**FIRE SERVICE AGENCY
 REVIEW**

Address of Site 13195 NW McNamee Road, Portland MCO 97231
 Map & Tax Lot: 2N1W32B703 'R' number R649631870
 Description of Proposed Use: Single Family Dwelling
 Total Square Footage of Building (including roof projections, eaves & attached structures): 4,994
 Applicant Name: Dieter Waiblinger Phone: _____
 Mailing Address: 604 NE 84th Circle
 City: Vancouver State: WA Zip Code: 98665 Email: dieter@yogalifeink.com

Fire Agency completing this form: Tualatin Valley Fire & Rescue Date of Review May 28, 2019

WAUBLINGER M49 RENEWAL
NO612
PRELIMINARY SITE PLAN
WITH FIRE BREAKS

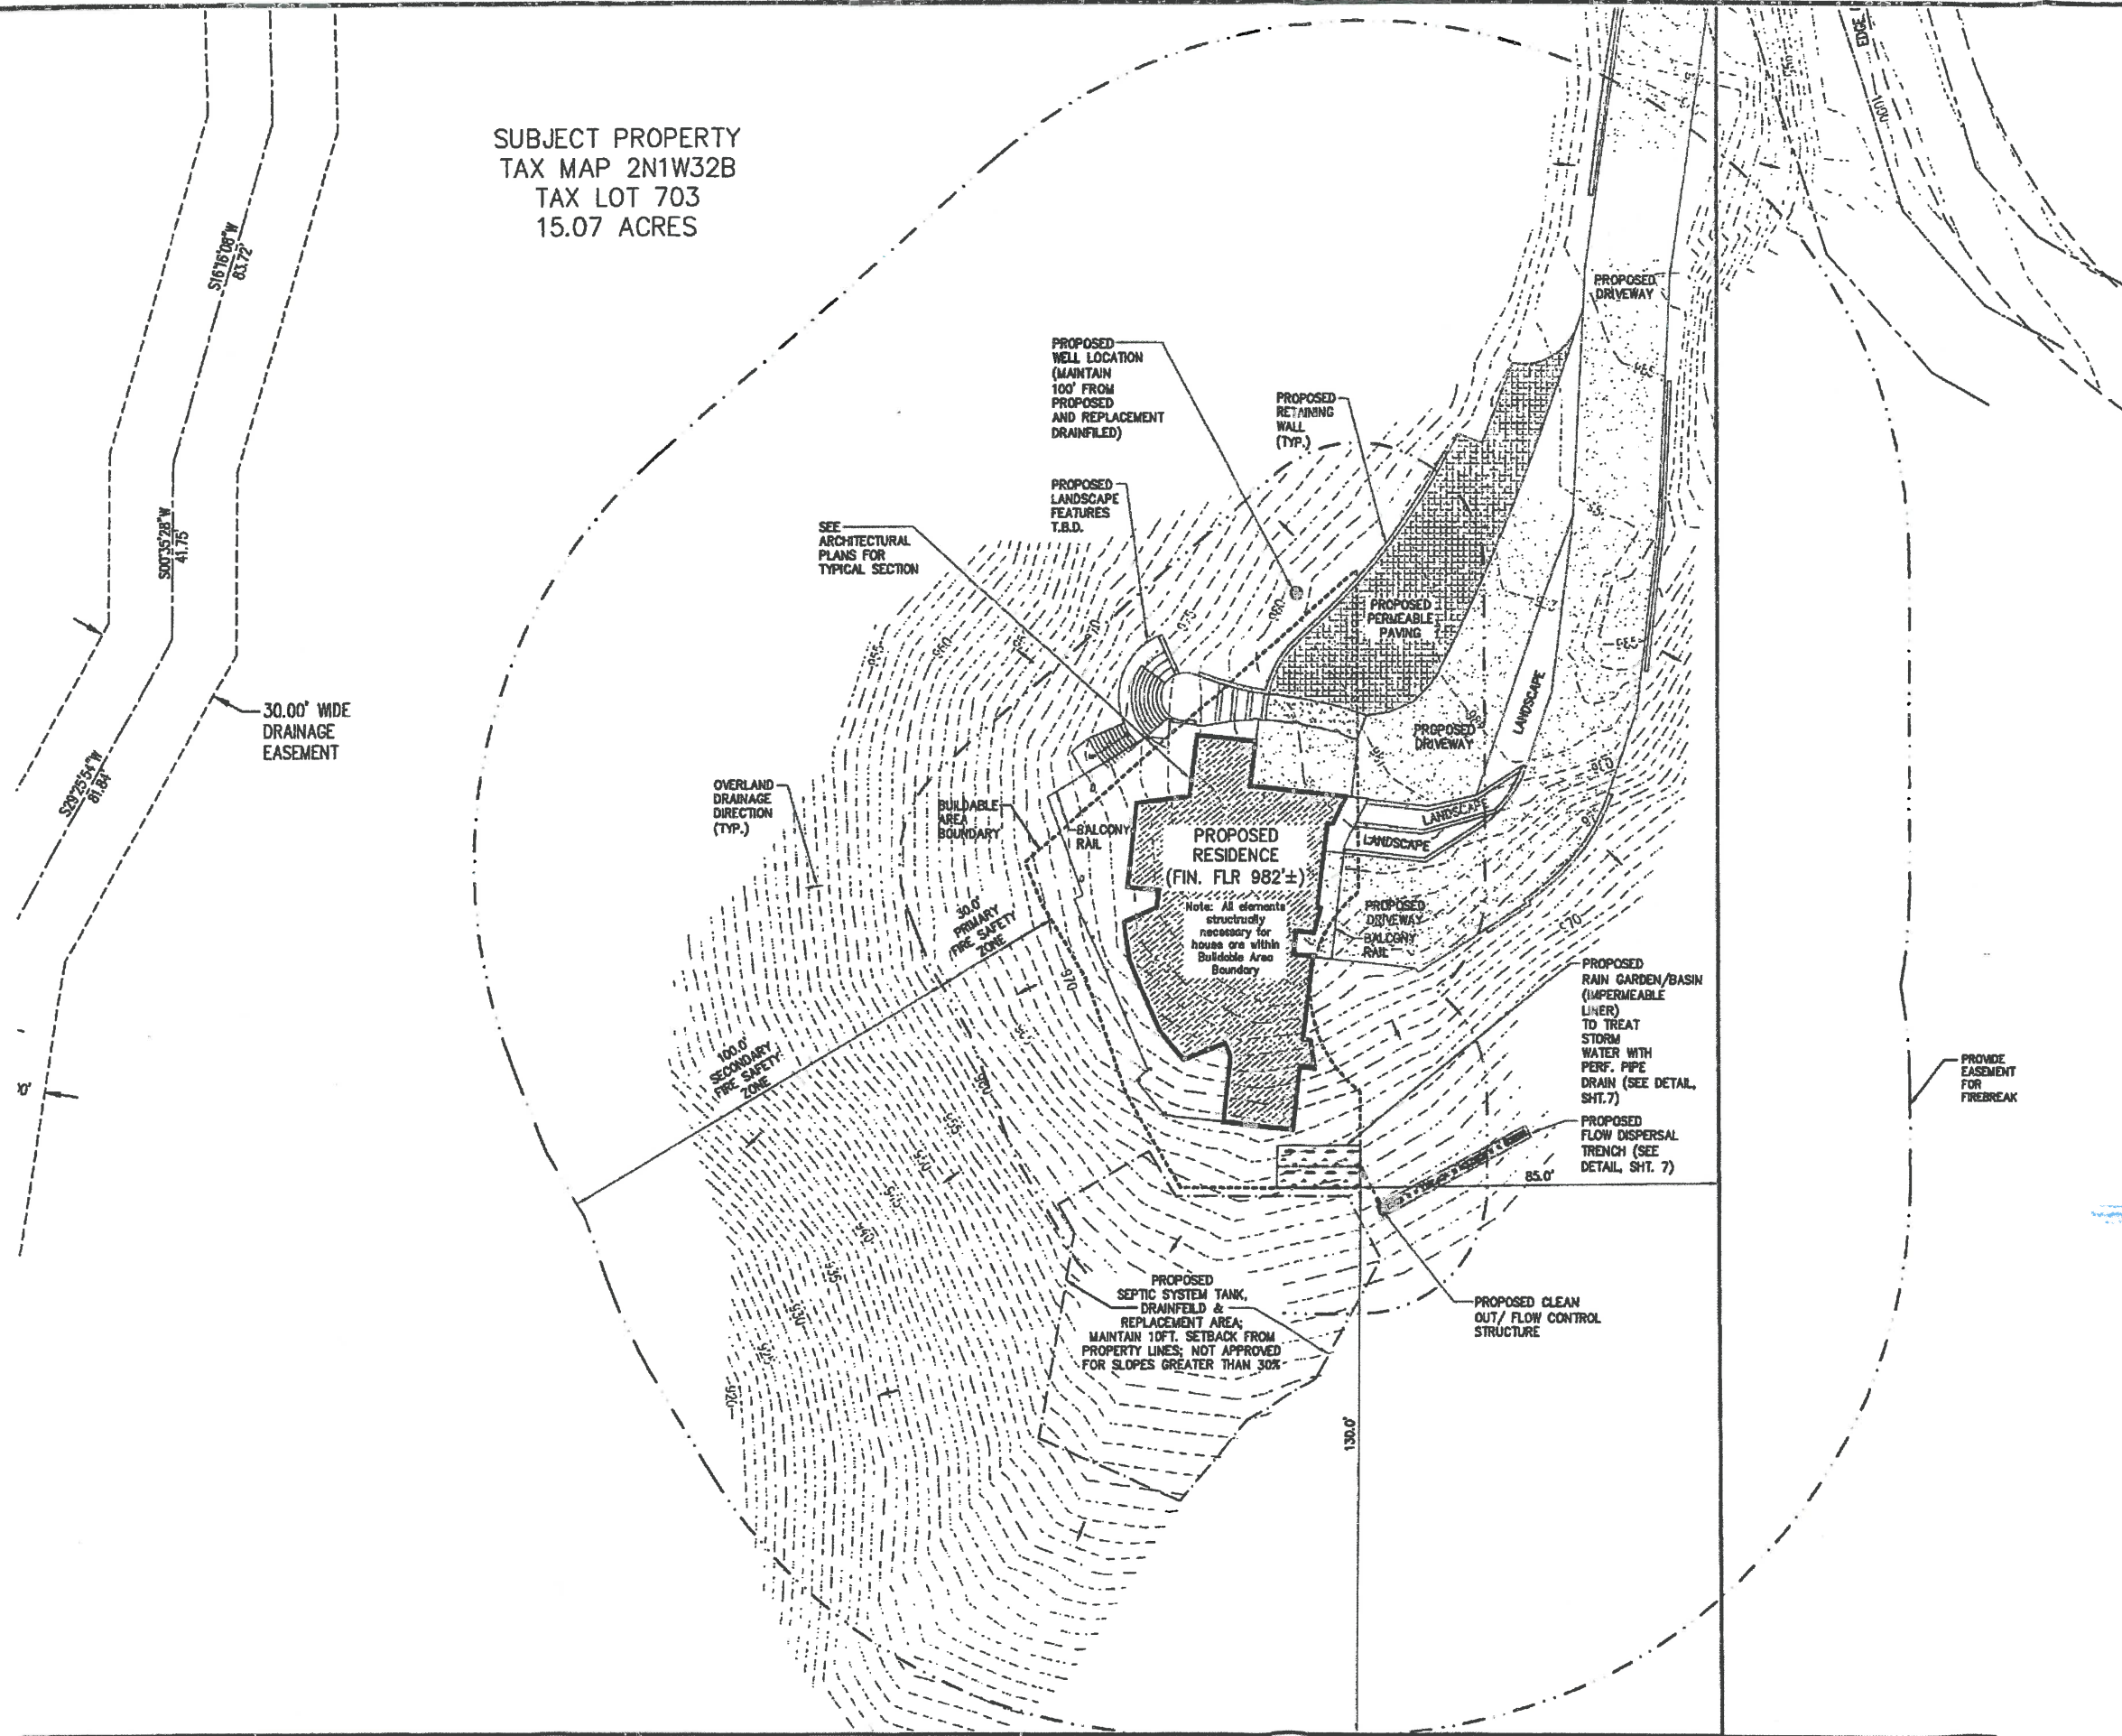
Applicant proposes installation of an NFPA 13 D fire sprinkler system in lieu of a fire apparatus turnaround, OFC 503.1.1 Ex. # 1.

Provide a physical address visible from both approaches of NW McNamee Road. OFC, 505. Driveway to be an all-weather surface capable of sustaining 60K gross vehicle weight and 12.5 wheel loading. OFC, 503.2.3
